Administration and Regulatory Affairs Department
Strategic Purchasing Division

Subject Letter of Clarification No. 1 for Fire Station No. 20 Structural Bracing and Wall Construction for the General Services Department

Reference: Bid Inv. No: S50-C23242

SHEET NO: A-202 BUILDING ELEVATIONS

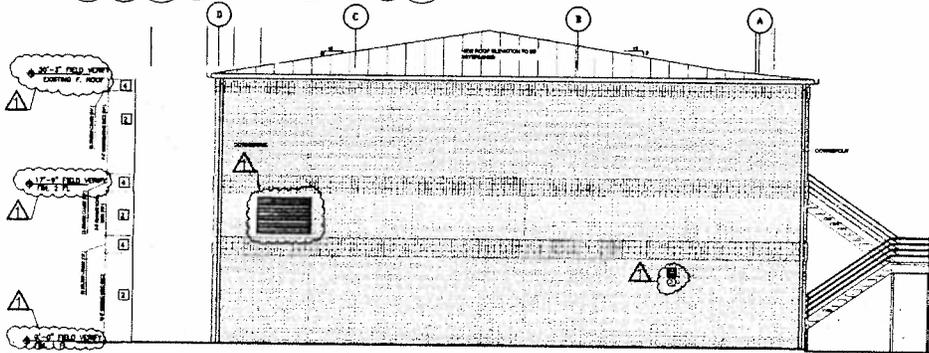
Question: Question regarding detail D1 of Drawing A-201 and A-202 should be changed to C1?

Answer: Refer to sketches 02 and 03 for correct detail reference. See attachment drawings.

SKETCH NO: 04

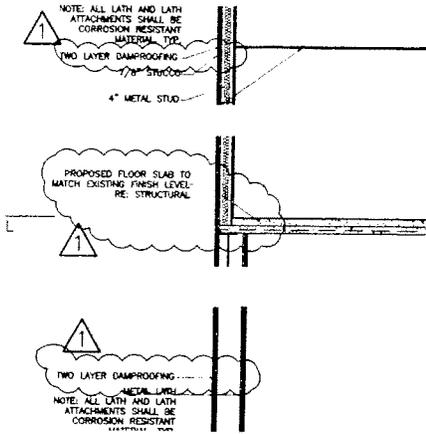
Question: What is the soffit material to be used?

Answer: All to be plaster soffits. Re: sketch 04 detail B6. See attachment drawings.

SHEET NO: A-102 ARCH MASTER 1ST FLOOR PLAN / MEZZ PLAN

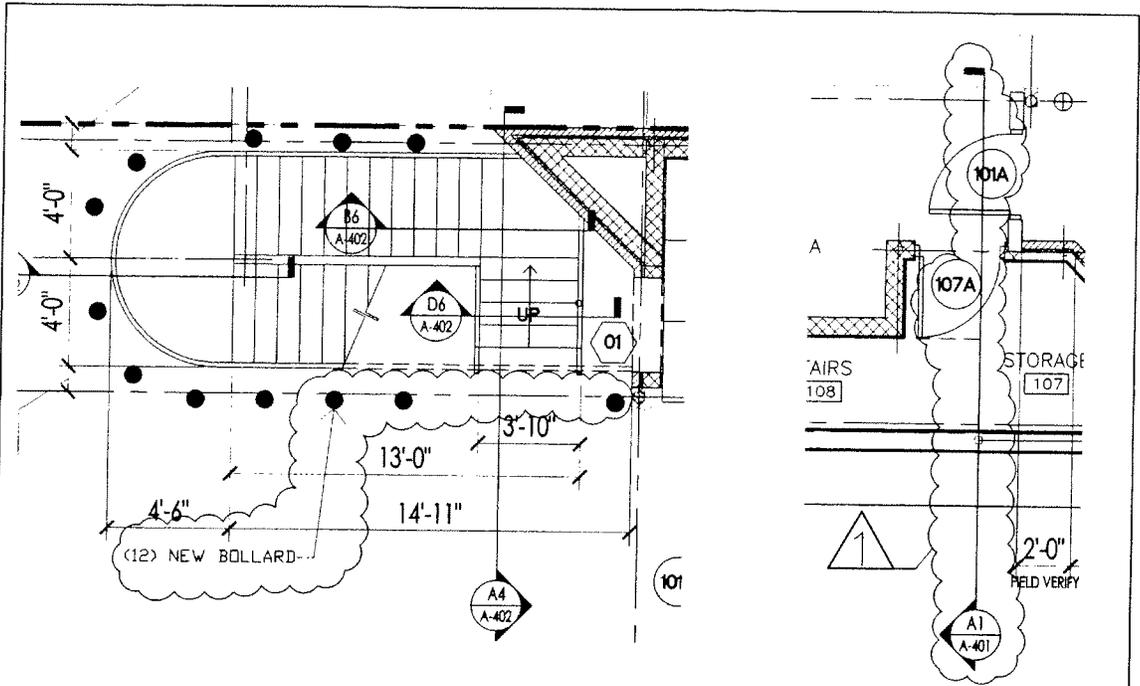
Question: Door schedule showed doors 101A and 101C as existing however they are not existing.

Question: Drawings show windows #01 and #02 as existing however they are not there.

Answer: These were removed during demo therefore new doors shall be provided and installed by contractor as per attached sketch 06. See attachment drawings.

Answer: Windows removed in demo. New windows shall be provided and installed by contractor as per sketch 06. See attachment drawings.

CITY OF HOUSTON
 GENERAL SERVICES
 DEPARTMENT
 SKETCH NO: SK10

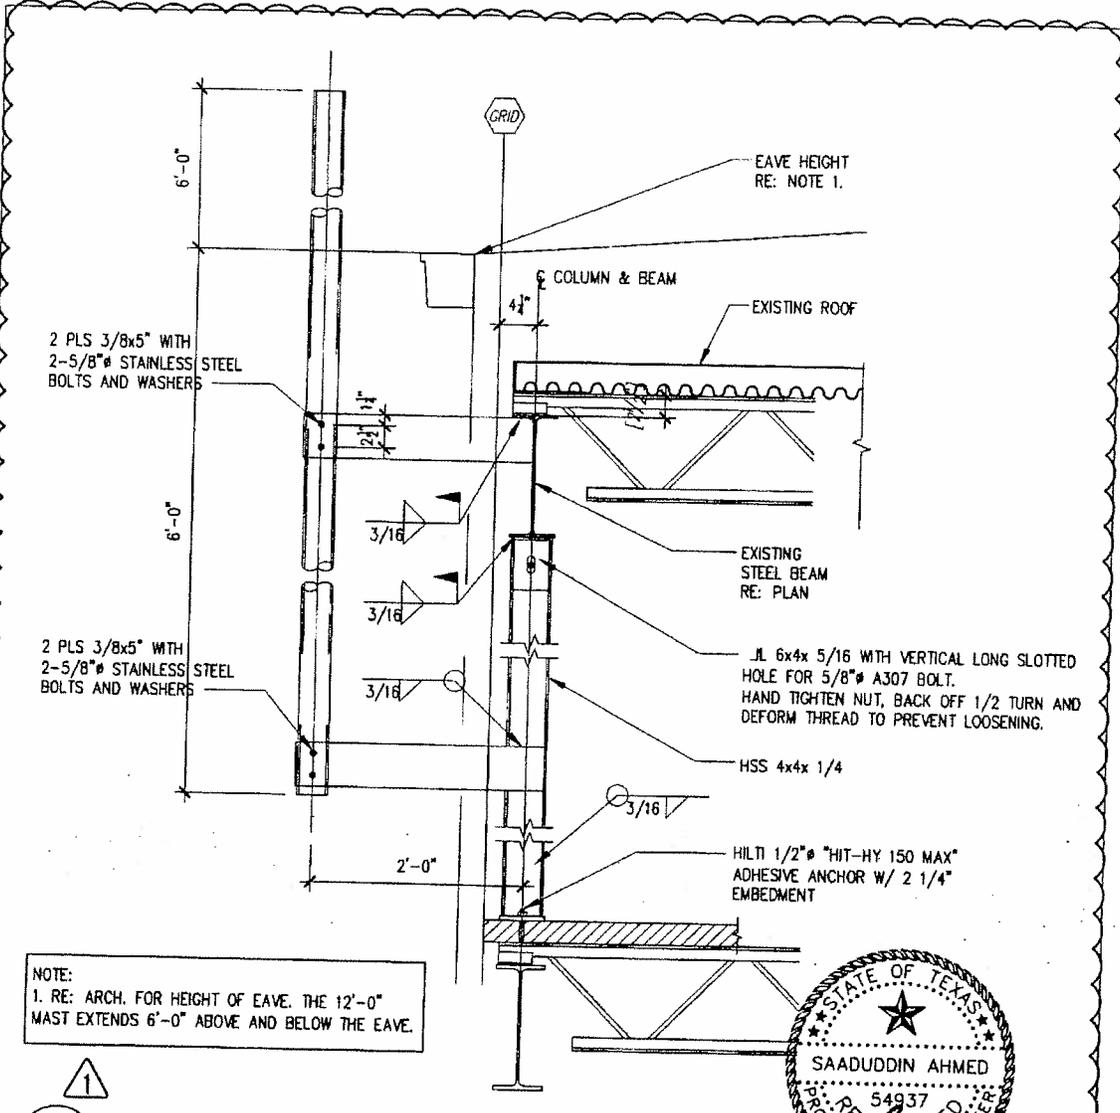
Question: Drawing A-201 and A-202 shows the communications antenna poles to be installed. Please provide details.

Answer: Detail is shown in Sketch 10 & 11. See attachment drawings.

SKETCH NO: SK12

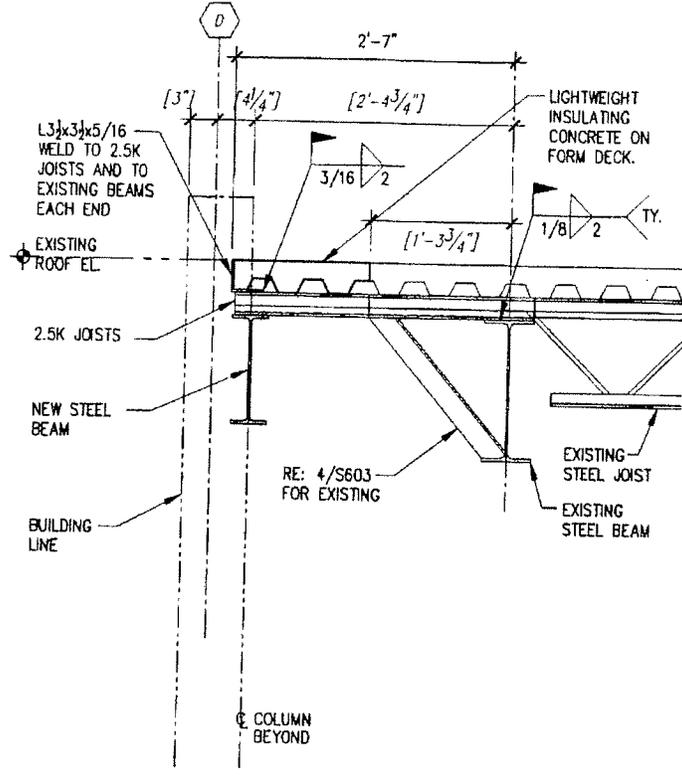
Question: Drawing S303 shows new W12x19 on column line A and D, between line 3 and 4. Section 6 /S603 do not show such steel beam.

Answer: Detail is shown in Sketch 12. See attachment drawings.
